### **C550 Camera Bezel Dropping/Missing**

Our Reference: SI24 3 2004

Product/System: C550

Subject: C550 Camera Bezel Dropping/Missing

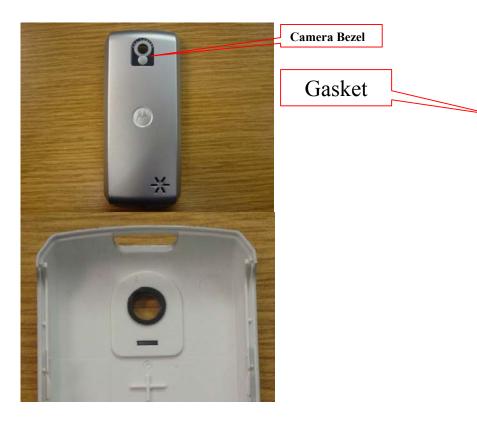
The issue was found in China. Customers complain C550 Camera Bezel Dropping/Missing from battery door.

The initial analysis show Camera Bezel hasn't enough adhesion. The supplier Banshing has change the process to get enough adhesion on Jan 9, 2004. But the bezel failed even after date code BS040109 (YYMMDD). Further analysis show the issue is generated by compression force of the gasket between the camera and the bezel.

In addition, due to focusing problem the tolerance on the camera height of the following Rev A camera module has changed from  $\pm$ 0.15 mm to  $\pm$ 0.21/-0.15 mm. In this case, the forces against the bezel will increases a lot again.

The design team has decided to remove the gasket to avoid compression force. The design team is pursuing the re-design of new thinner gasket.
